ADDENDUM NO. 1

LOXAHATCHEE RIVER DISTRICT

Science Center at Jupiter Inlet Lighthouse Outstanding Area

PROJECT NO. ITB # 22-009-00119

FLOOR PLAN -
SCIENCE CENTER

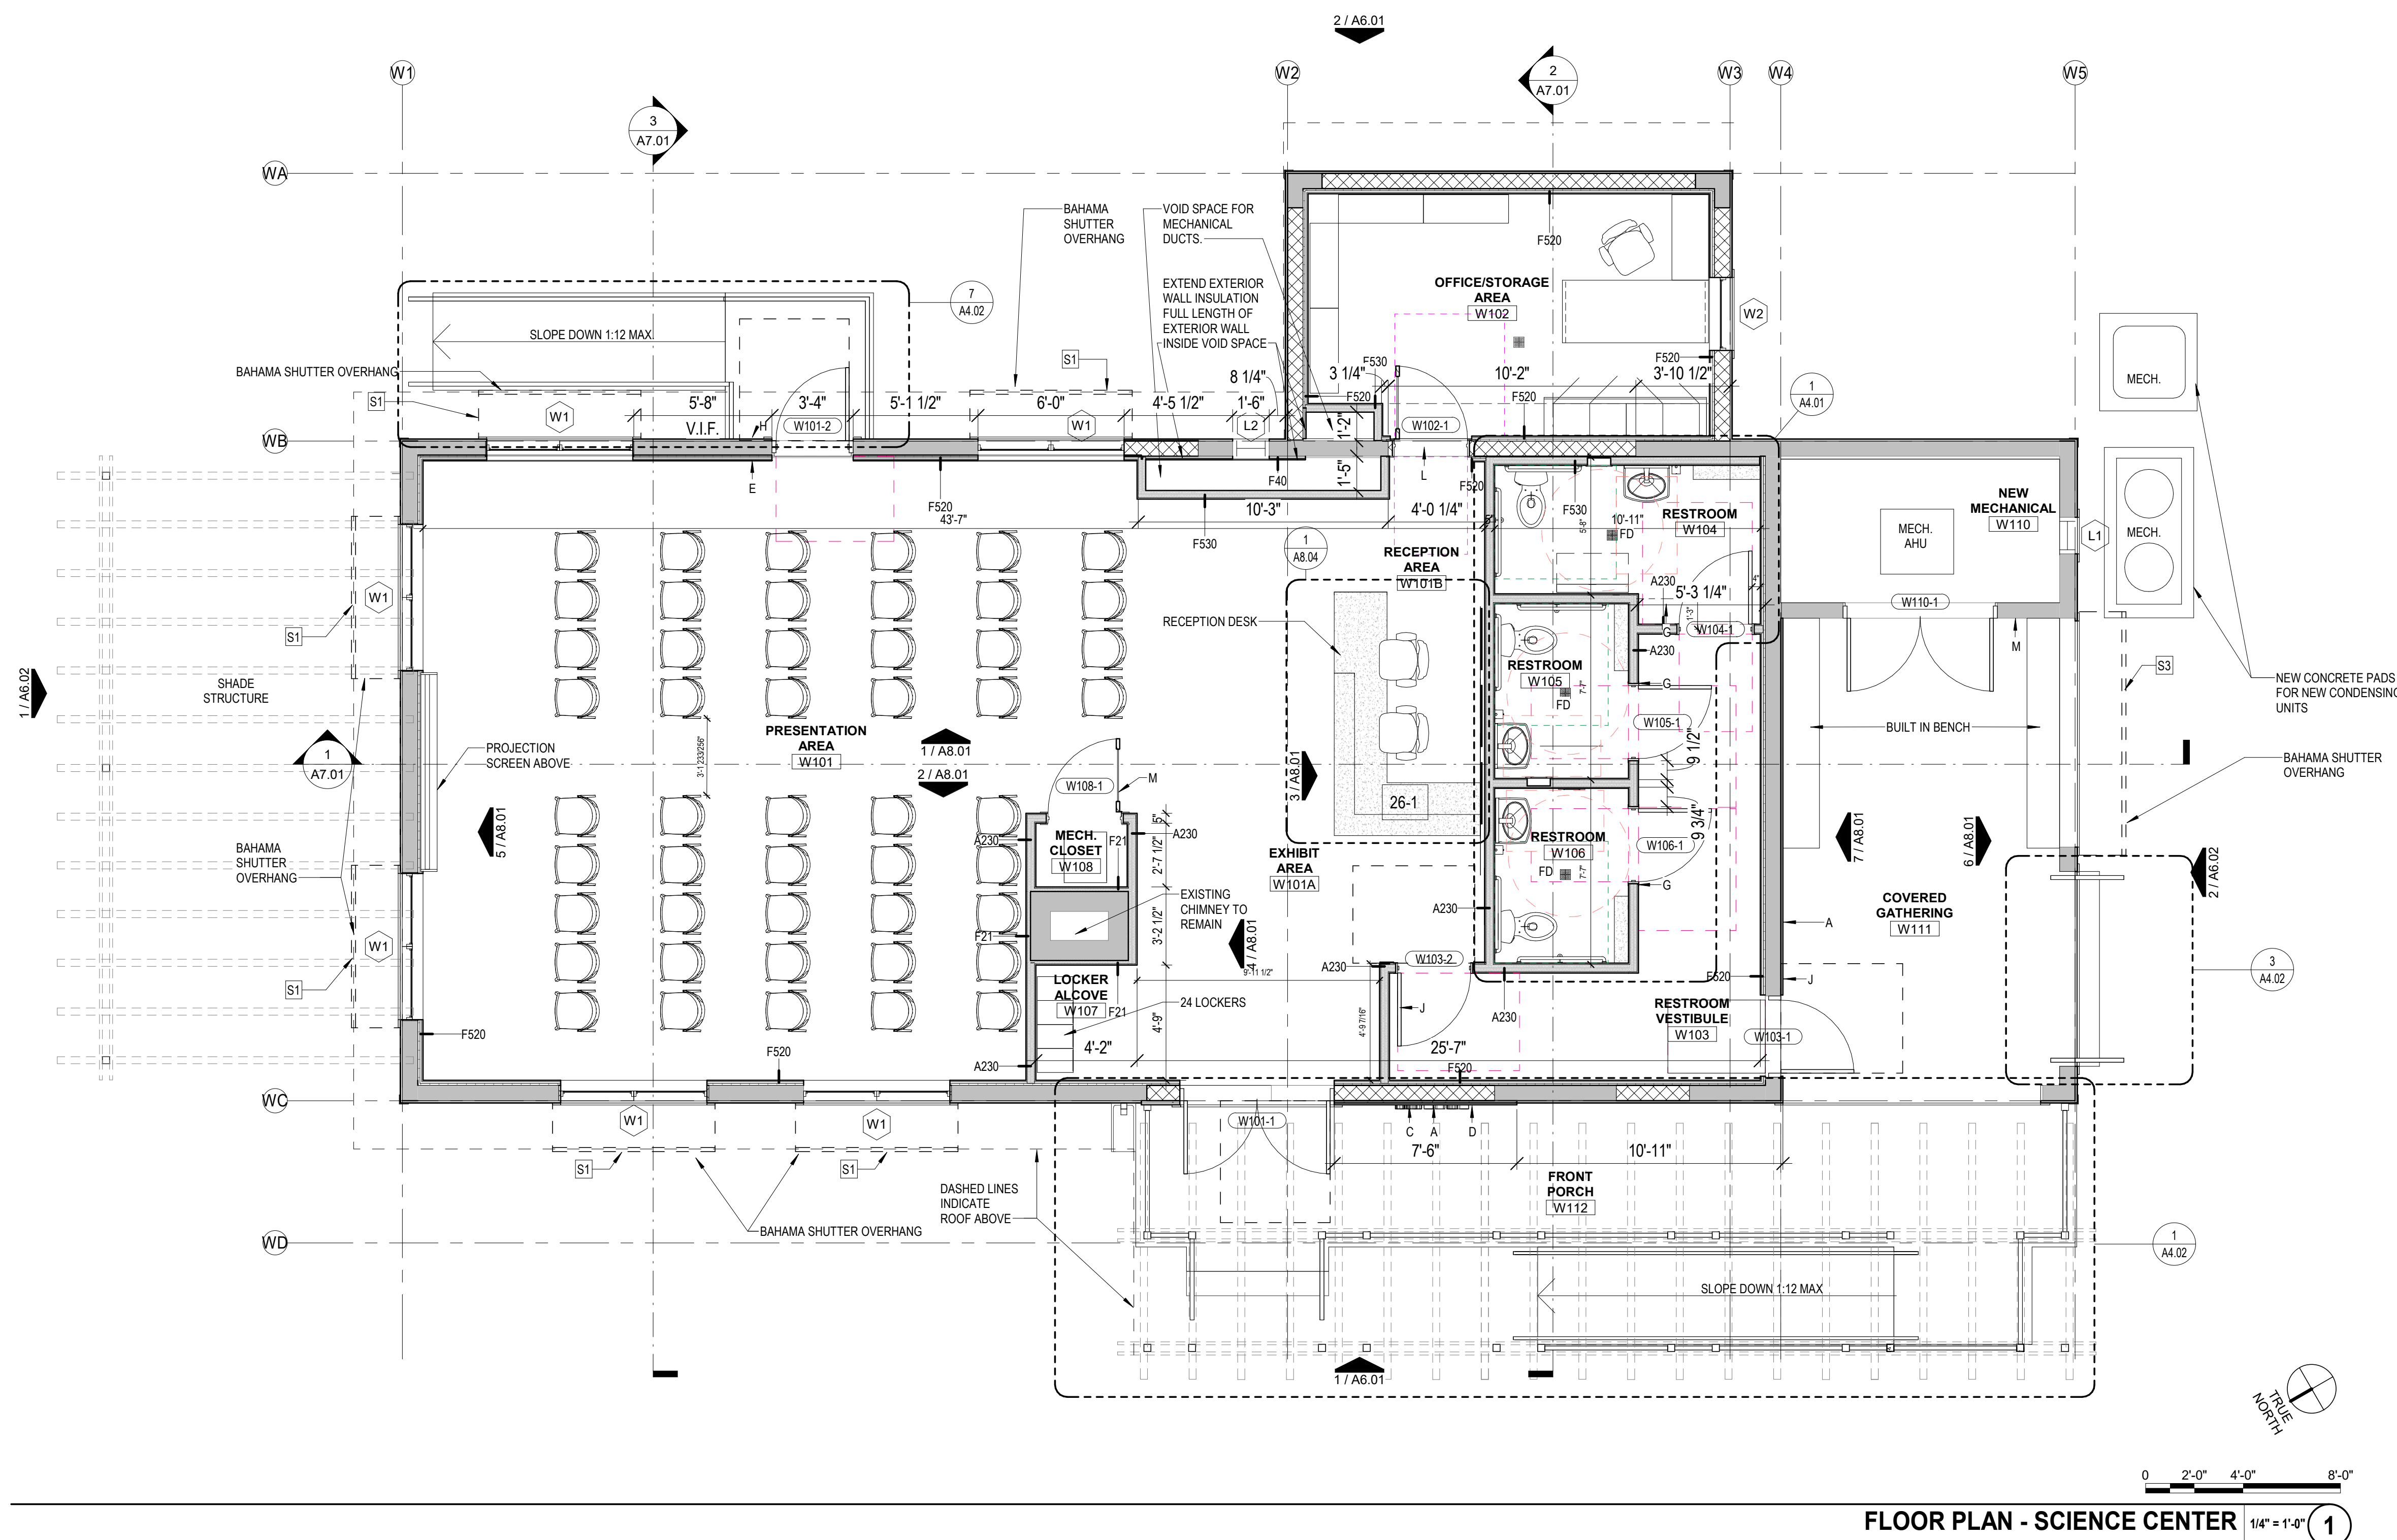
Q1 – In reviewing the plan documents I have found that 2 plan sheets are missing from the download. Plan sheet A2.10 and A2.11. In the download sheet 33 and 34 of 107 is AF2.10 and AF2.11 also in the download sheet 54 and 55 of 107 are again AF2.10 and AF2.11. Kindly forward the missing documents.

A1 – Sheets A2.10 and A2.11 are included with this addendum.
